**ADDENDUM NO. 02  
To Drawings and Specifications dated 02/07/2024**

**Date: FEBRUARY 07, 2024**

**PROJECT:** **Sequoia Elementary School HVAC Upgrade & Modernization  
A#04-121952**  
Westminster School District

28 DEMO RCP - BLDG A-1  
1/8" = 1'-0"

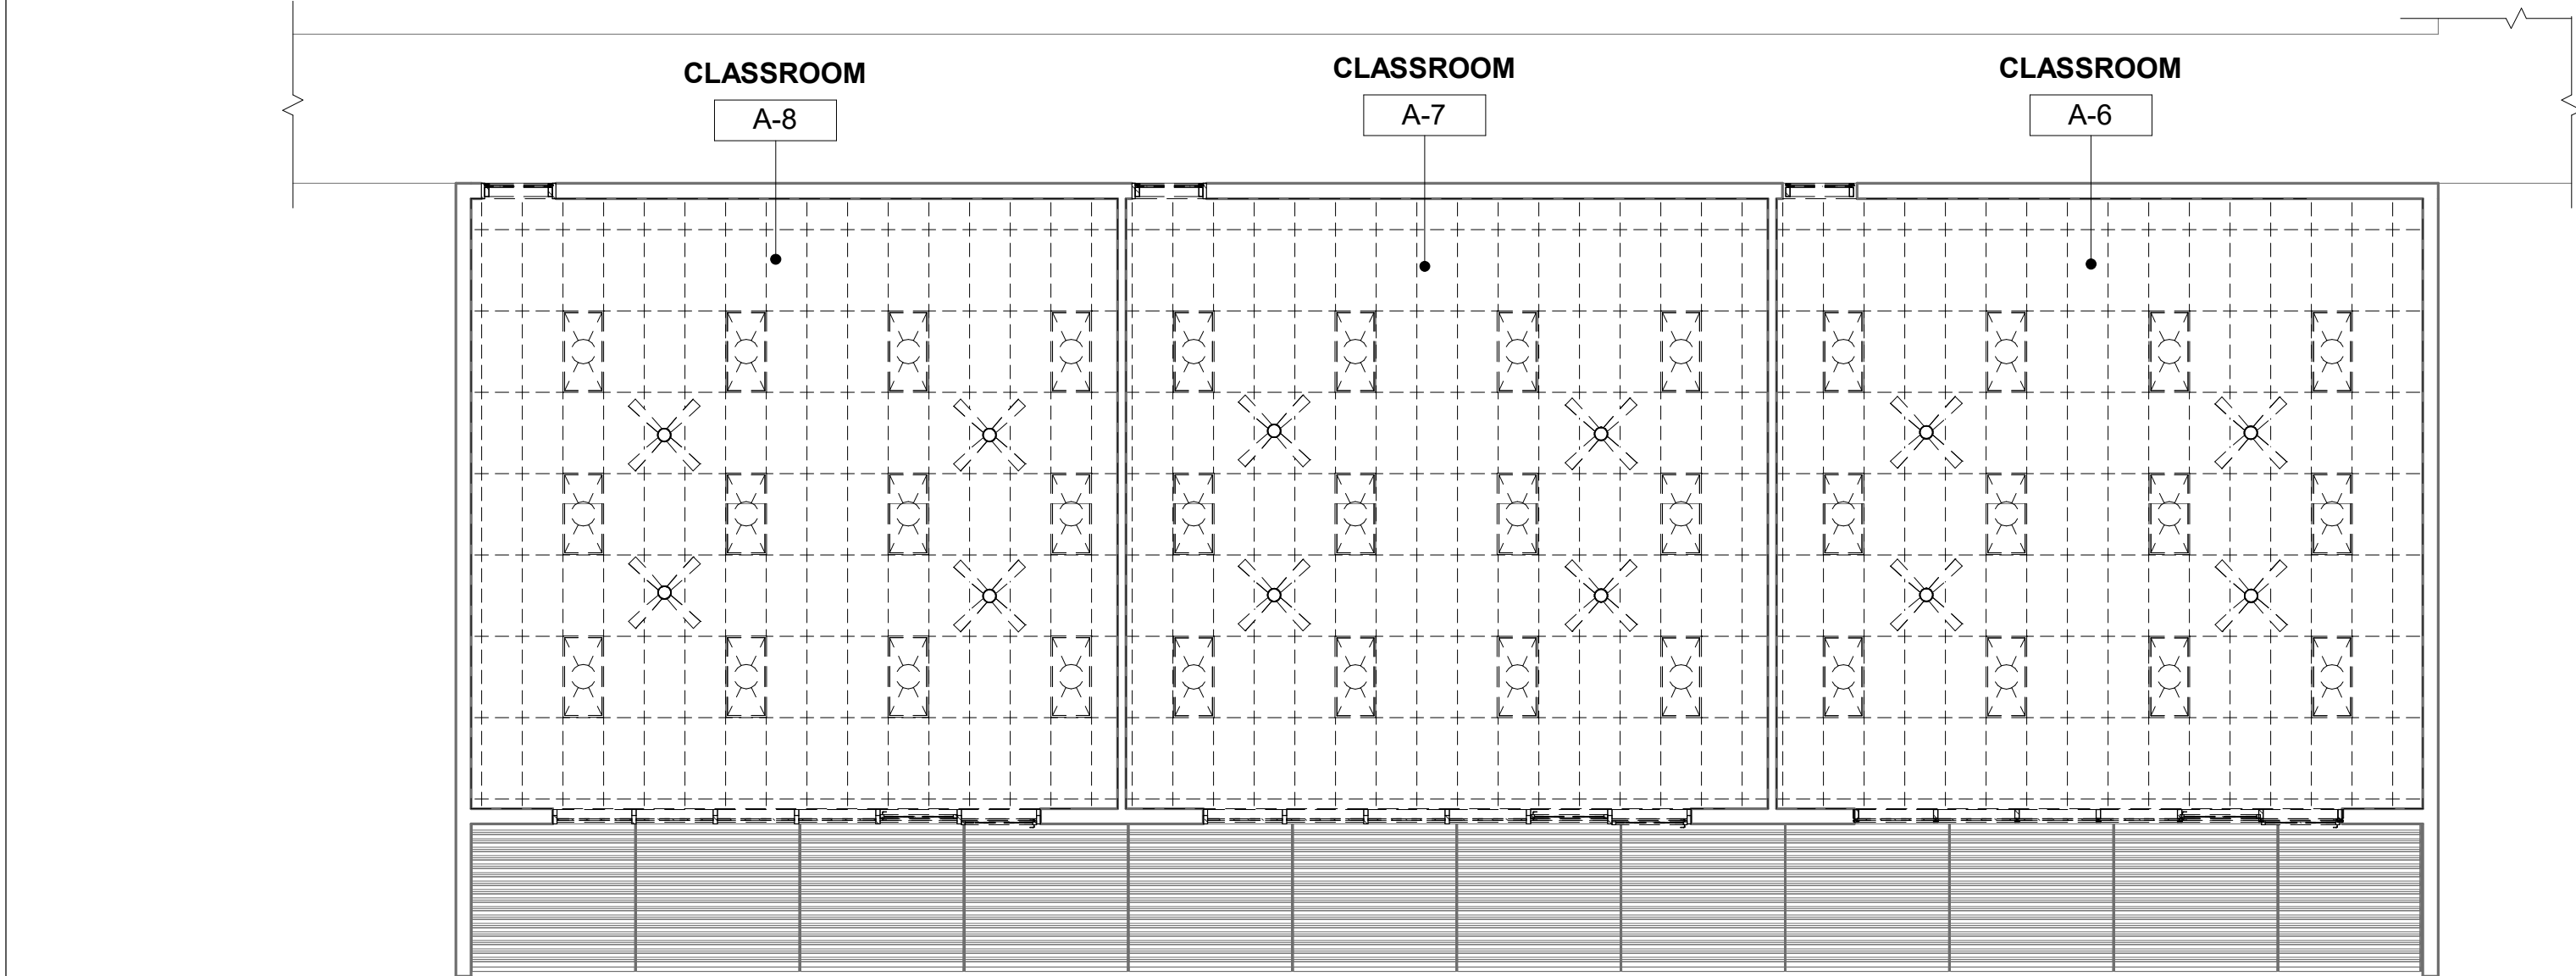
2. Detail "13 – Demo RCP – Admin BLDG"
  - a. Added "(E) MDF/IDF to remain and protect in place."
3. Detail "15 – Demo RCP – BLDG A-3"
  - a. Revised Demo RCP in "Girls' RR, Custodial & Boys' RR."
4. Detail "28 – Demo RCP – BLDG A-1"
  - a. Revised Demo RCP in "Office A-10 & Storage A-9."

## 2 DEMOLITION REFLECTED CEILING PLAN

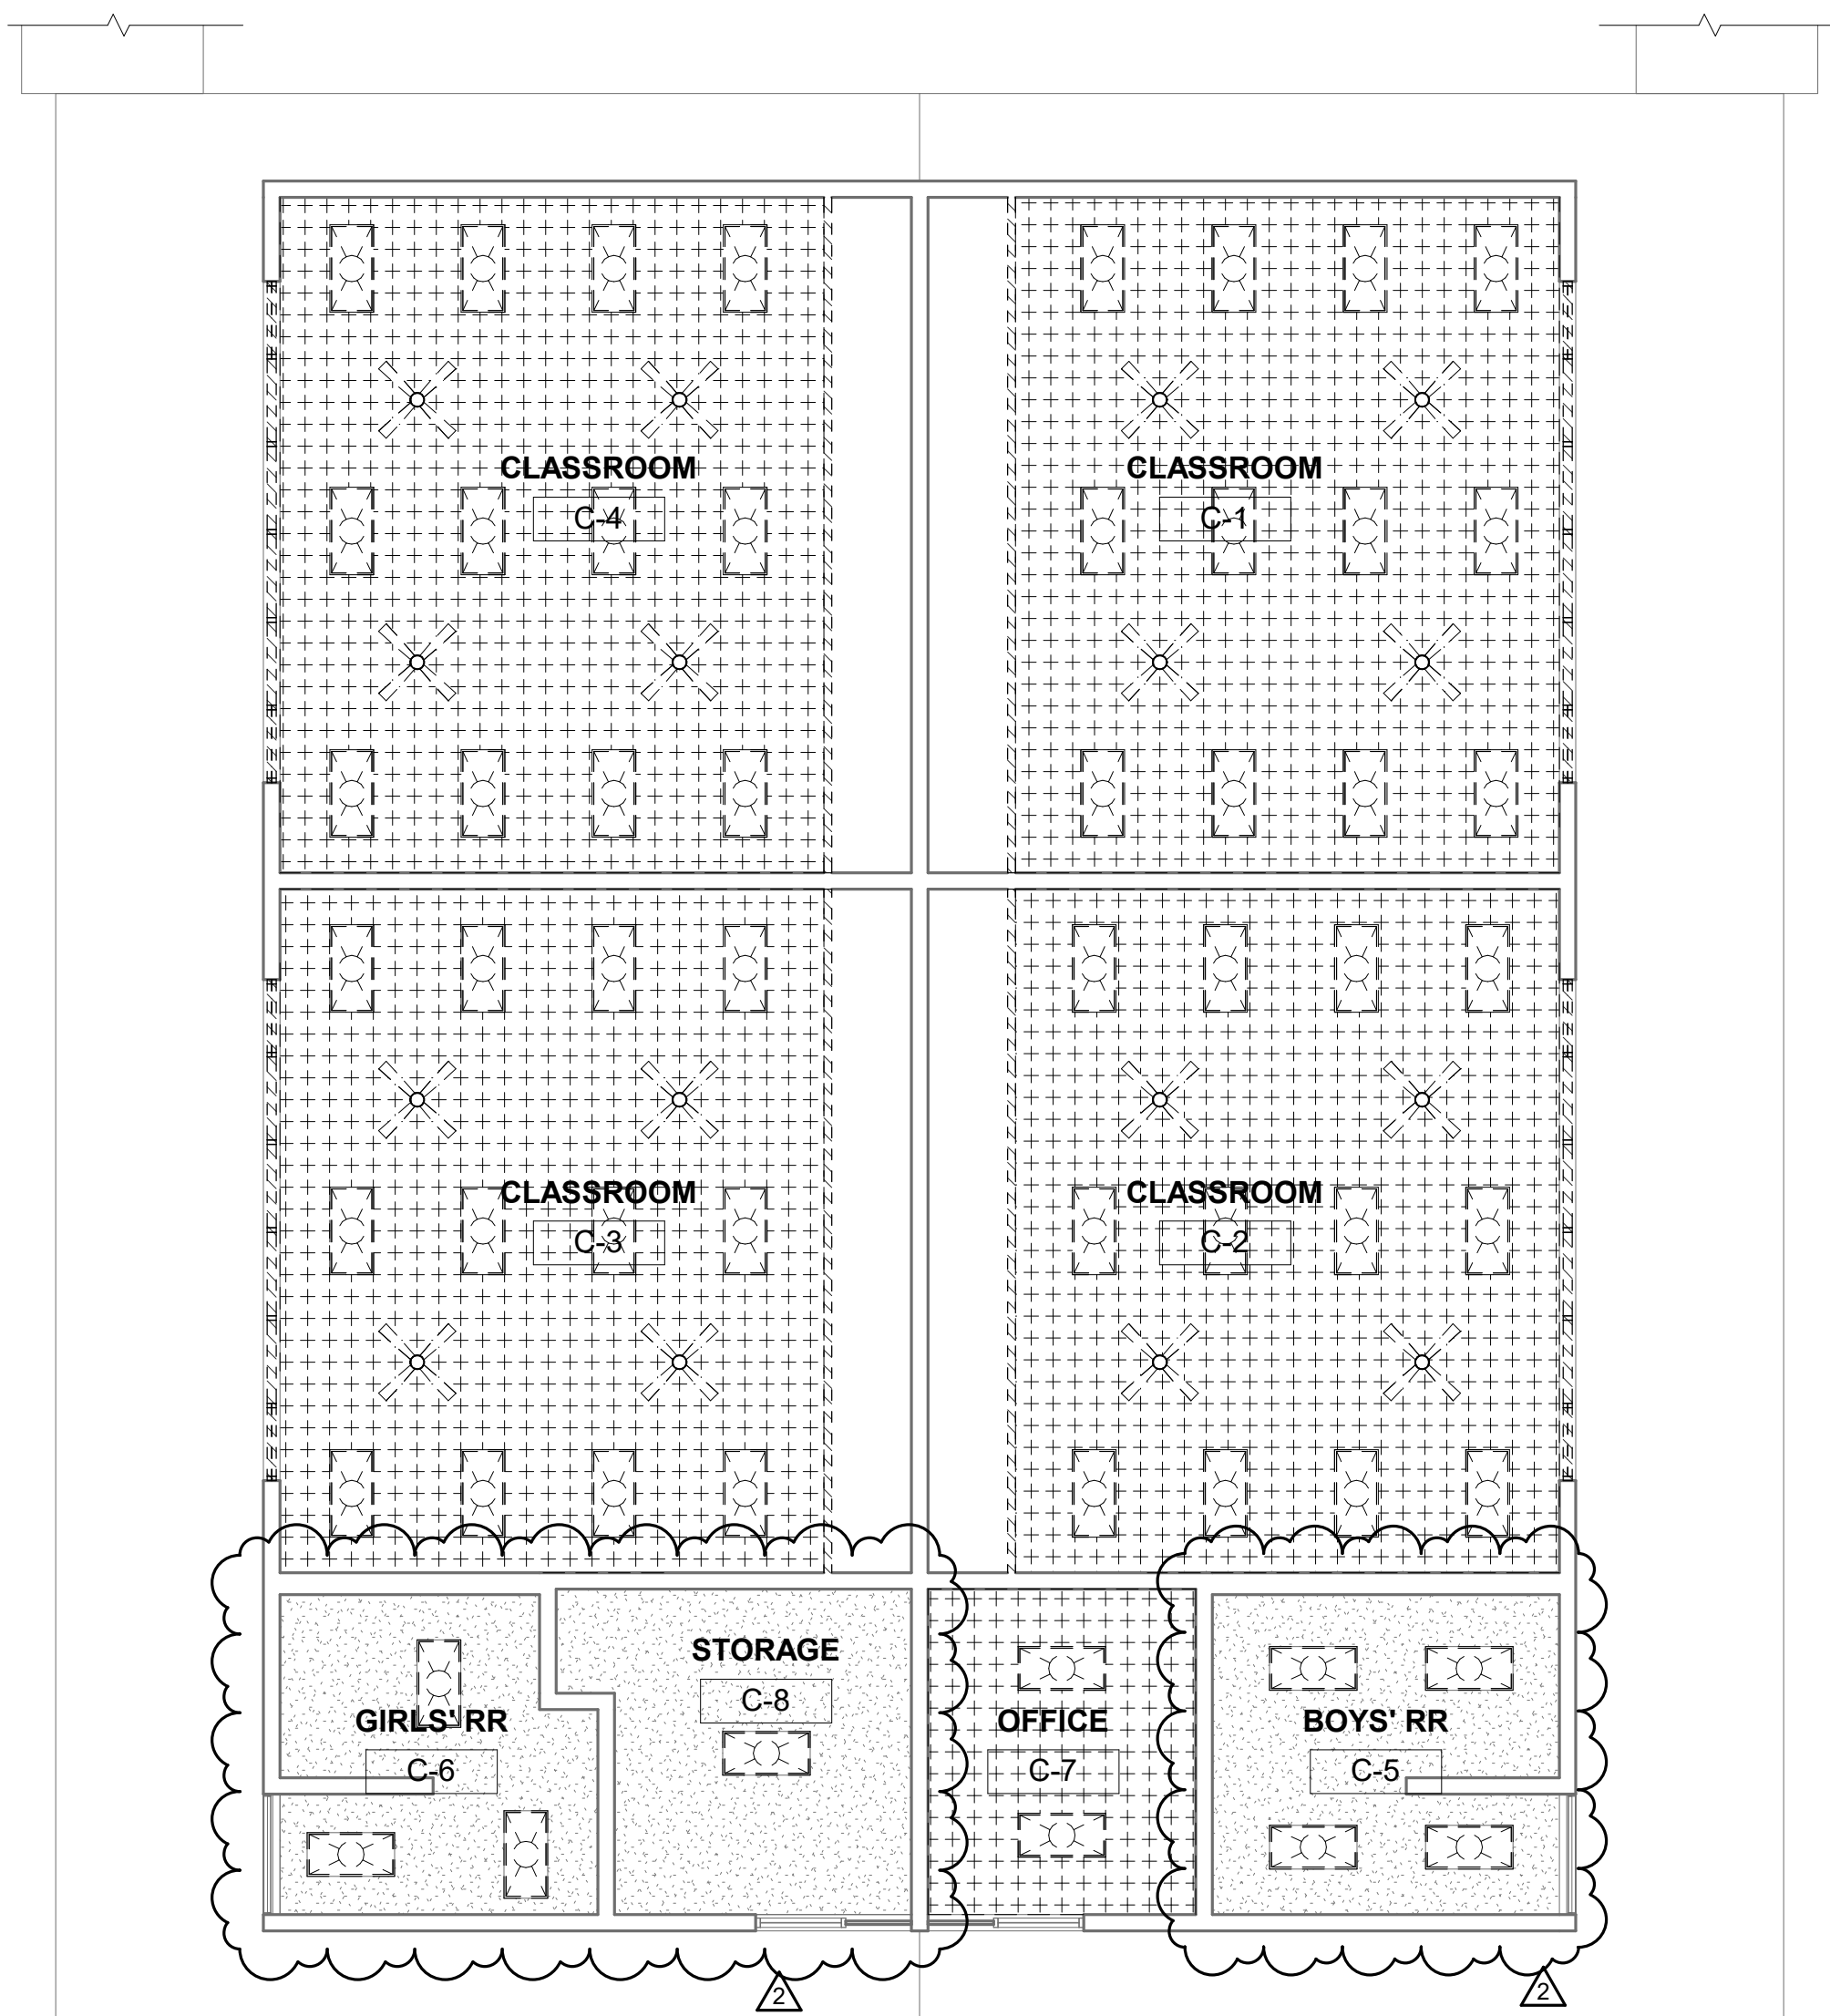
1. Detail "2 – Demolition Reflected Ceiling Plan"
  - a. Revised Demo RCP in "Girls' RR, Boys' RR & Storage."

4 RCP - BLDG "LAB/LIBRARY"

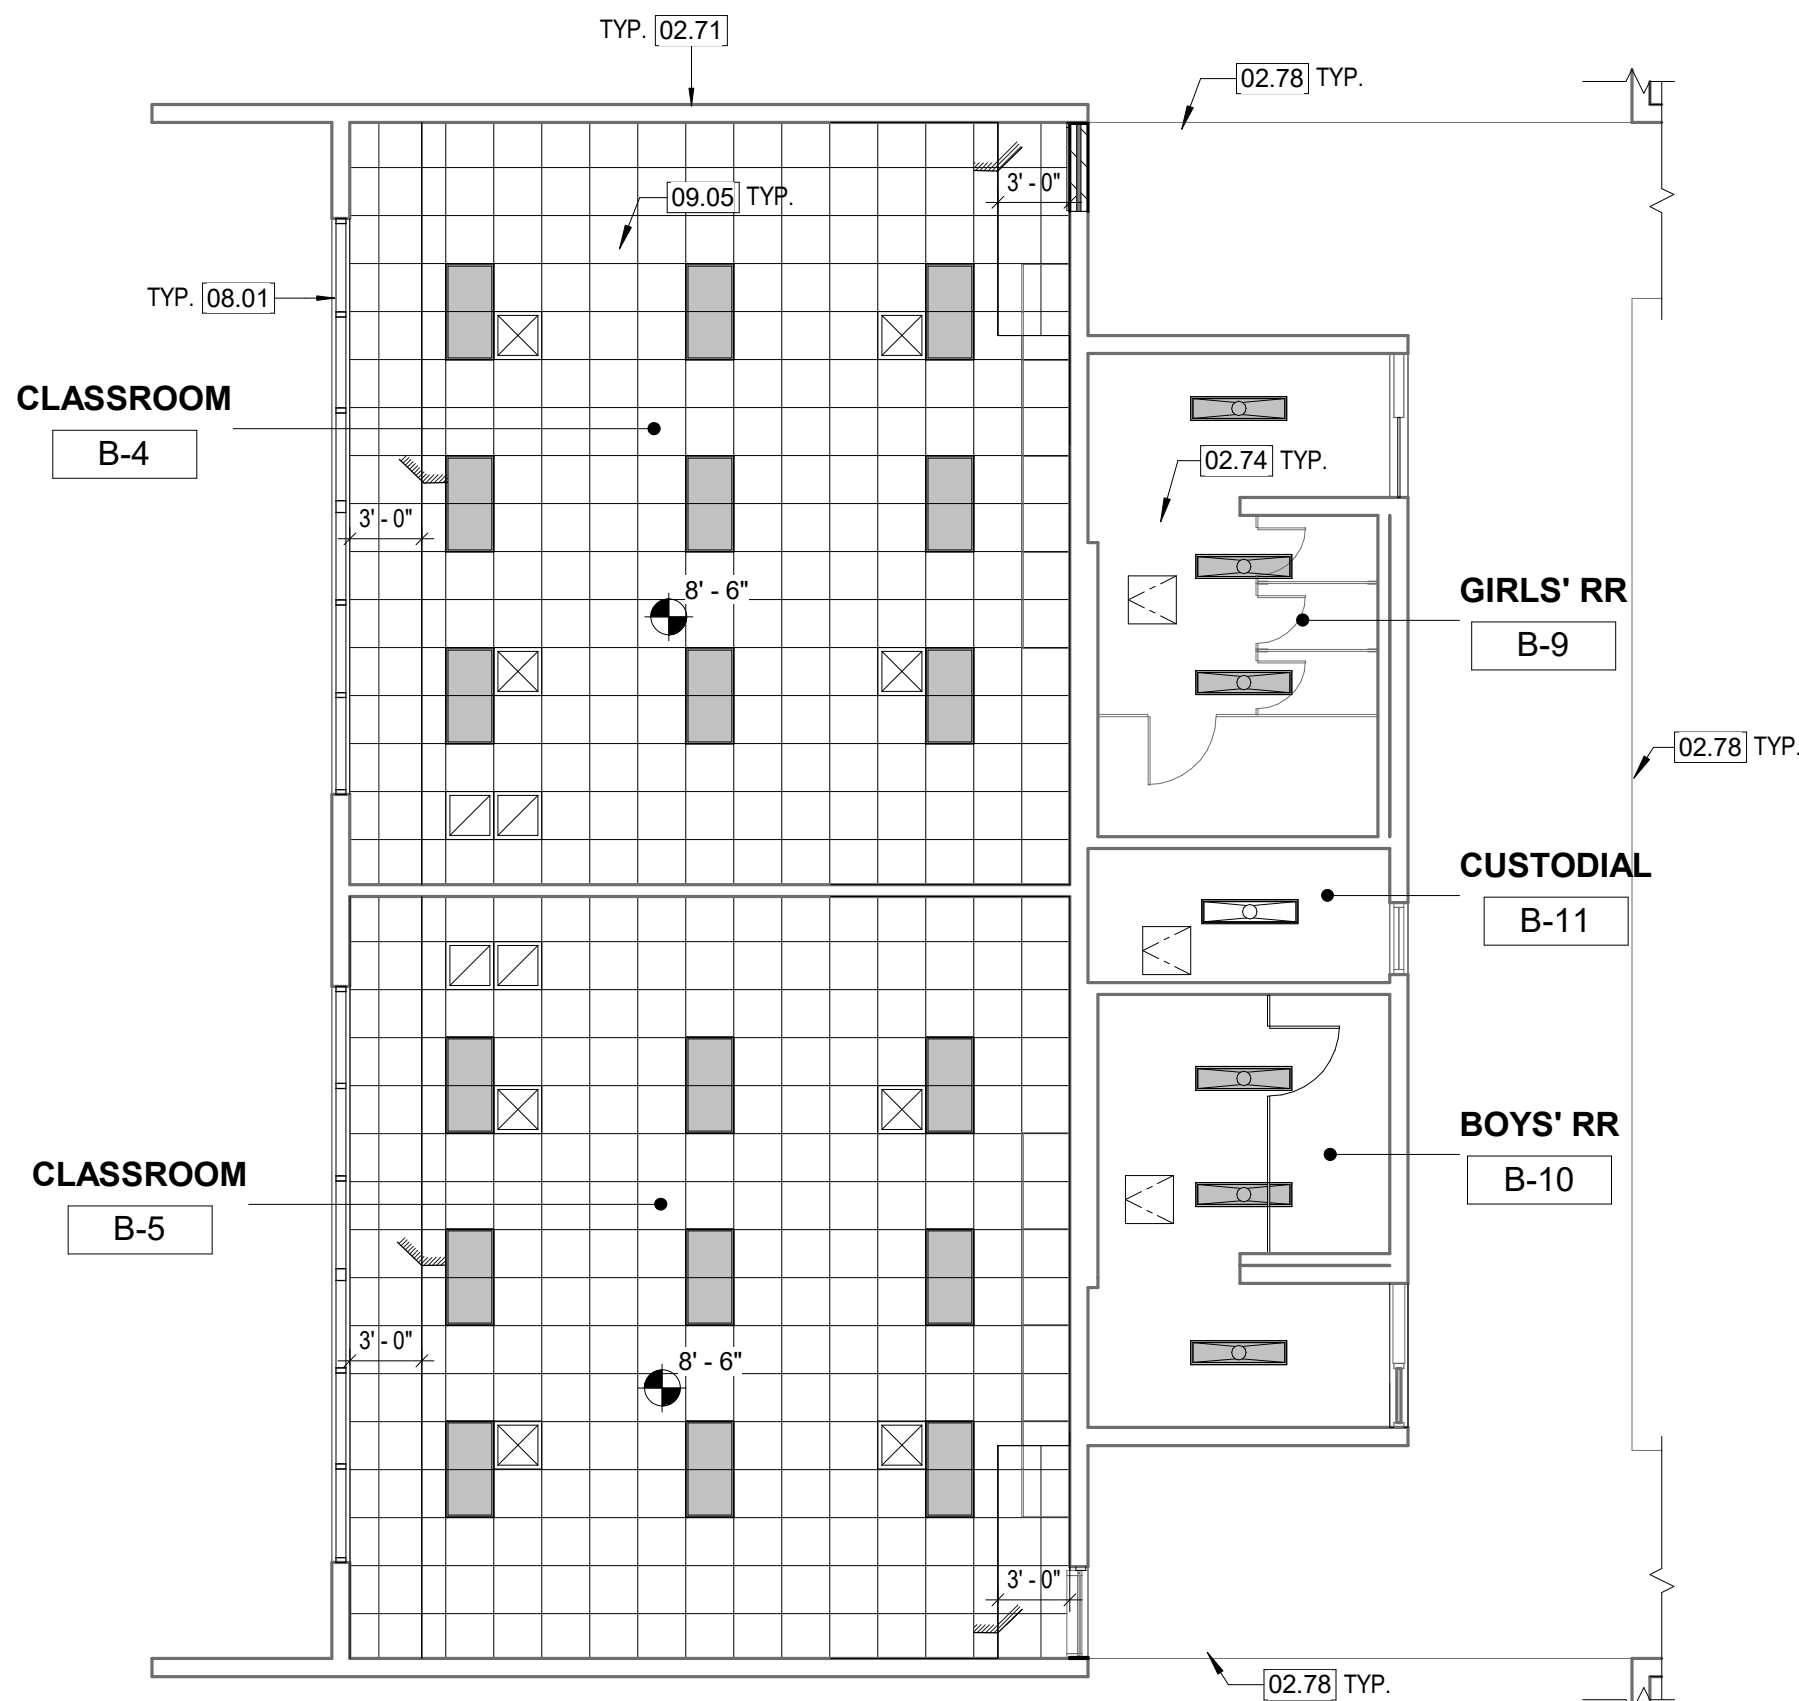
2. Detail "4 – RCP – BLDG LAB/LIBRARY"
  - a. Revised RCP for Computer Lab.
  - b. Added keynote "02.81 & 09.08."

16D TYP BLDG K - WEST INTERIOR ELEVATION  
1/4" = 1'-0"

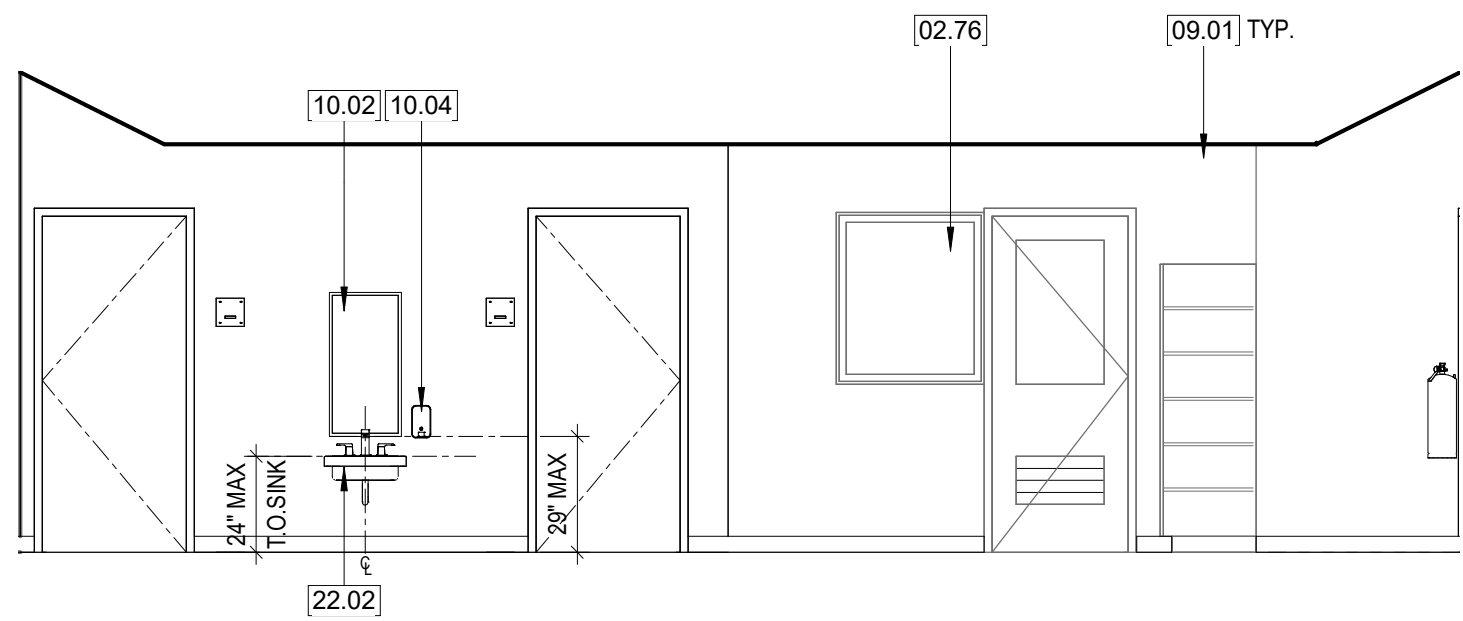
2. Detail "16D – Typ. BLDG K – West Interior Elevation"
  - a. Added "Remove and reinstalled (E) power & (E) data after tackboard reinstallation. Typ."

4D TYP BLDG C - WEST INTERIOR ELEVATION  
1/4" = 1'-0"

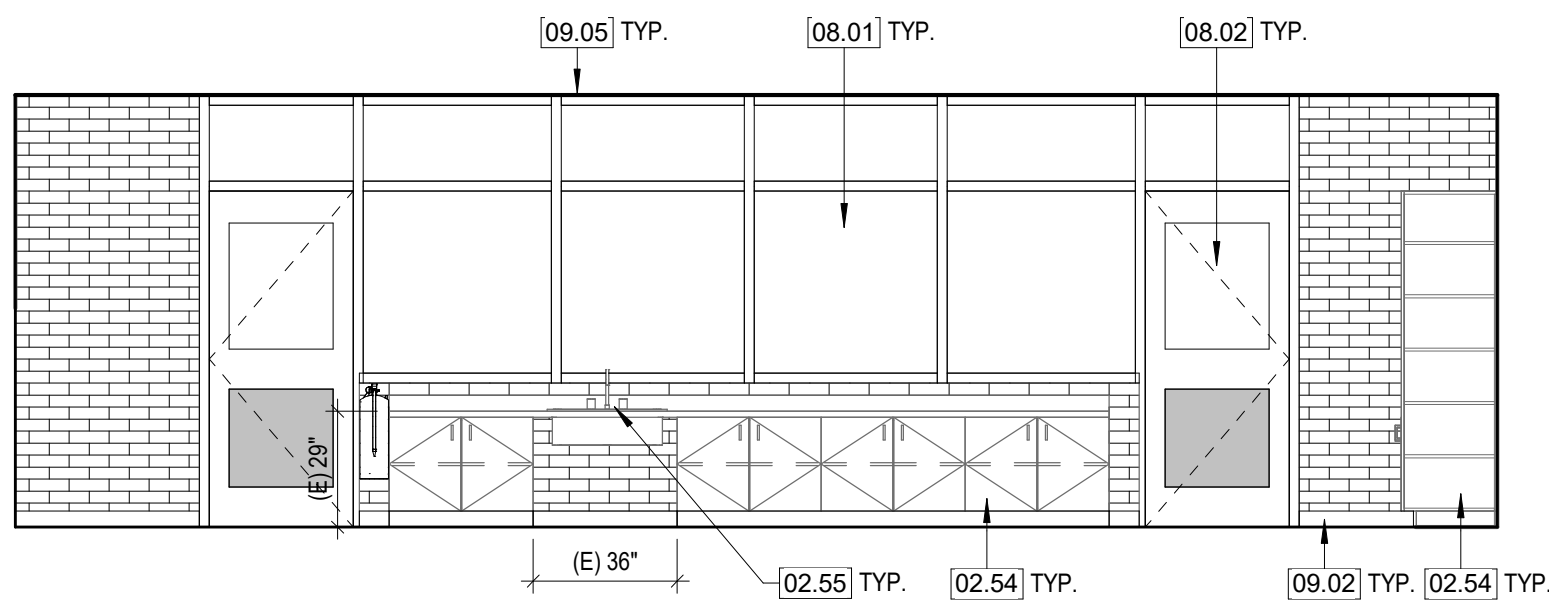
1. Detail "4D – Typ. BLDG C – West Interior Elevation"
  - a. Added "Remove and reinstalled (E) power & (E) data after tackboard reinstallation. Typ."
